# Position on the review of Energy Labelling Regulations 2015/1186 (ENER Lot 20) for local space heaters and 626/2011 (ENER Lot 10) for air-to-air heat pumps, air conditioners, and comfort fans

22 August 2022

**On the ‘Labelling Consultation Forum 24 June 2022 V2’ presentation**

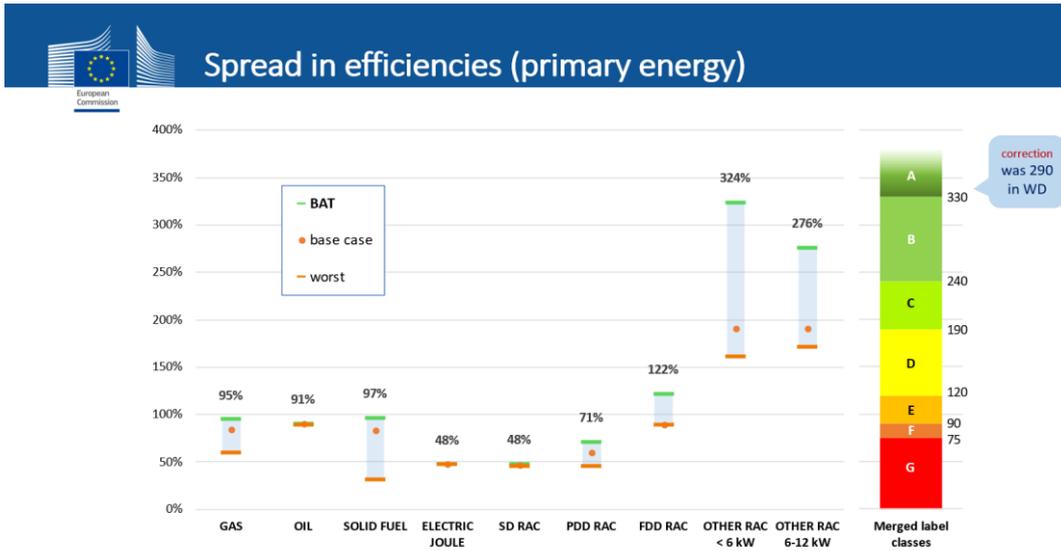
As shown above, in heating it is proposed to correct the lower limit of class A from 290 % to 330 %. EPEE assumes that this new value has been determined based on EPREL scrutiny. However, it is EPEE’s assessment that this value is inaccurate and is actually a typo when cross-referenced against other sources of information for the assumed BAT units. For this reason, a lower eta value for class A limitation is more appropriate for the current and future market situation.

EPEE strongly disagrees with the new technology specific energy efficiency classes. As already explained above, EPEE strongly believes that the approach to merge LSH, RAC and SD&DD is

- Heating RAC options 1 & 2:
  - As indicated, the limit for class A should be lower than 330 % (there is in the market no unit with and SCOP of 6,8; the current BAT remains at a SCOP of 6.2; typos in EPREL).

- EPEE strongly challenges the class distribution provided for under options 1 & 2 in heating. Under these new class limits, 95 % of the fixed RAC market falls in classes E, F, and G. For the following reasons, placing the majority of RAC products in the three lowest efficiency classes is counter to the Energy Efficiency First principle and provides misleading information to consumers:

- To remain true to the spirit of the merger proposal, split RAC should populate the top classes B, C and D. In any case, classes E, F, and G should not be populated by the most efficient technology.

- Heating RAC option 3 should cover RAC, LSH and SD&DD:
  - As indicated, the limit for class A should be lower than 330 % (there is no unit on the market at 6,8 SCOP; the current BAT remains at a SCOP of 6.2; typos in EPREL).

- To ensure appropriate differentiation, classes B, C, and D should be only populated by split RAC.
- Cooling options 1, 2, and 3 for fixed:
  - EPEE strongly challenges the class distribution provided with the newly proposed class limits. According to the above, 86 % of the fixed market would be distributed in classes

E, F, and G, despite the fact that split RAC is the most efficient cooling technology available. Therefore, RAC should rightly populate classes B, C, and D. The three lowest classes, E, F, and G should not be populated with RAC at all.

EPEE strongly urges the European Commission and the Member States to revise the proposed cooling and heating class distributions to ensure that they always guide the consumer to identify the most efficient technology providing the function required.

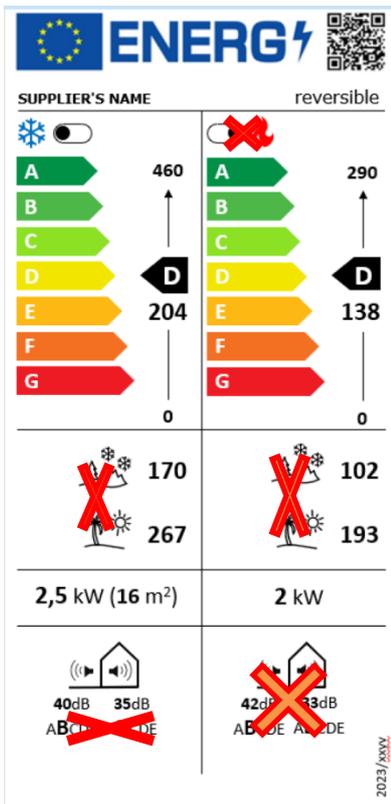
Clarification is needed on whether the declared control features must be integrated or if they can be supplied via web/app and as part of a product bundle/package, i.e., as an accessory, and how this should be reflected in the energy label. EPEE suggests limiting the declarations for the control features to one option (default one for the model) and enabling the digital generation of energy labels and declarations when additional options are added. Declaring all control features for units that may also be used in several combinations between indoor and outdoor units would be a challenging administrative burden in terms of generating all the required data and considering the obligation to upload to the EPREL database.

Finally, EPEE would like to raise concerns on the enforceability and verifiability by market surveillance of such requirements. Market surveillances will have to check whether the control features are correctly reflected in the declared seasonal efficiency and available for the consumer. It is currently not clear how this will be handled, and this approach should be clarified.
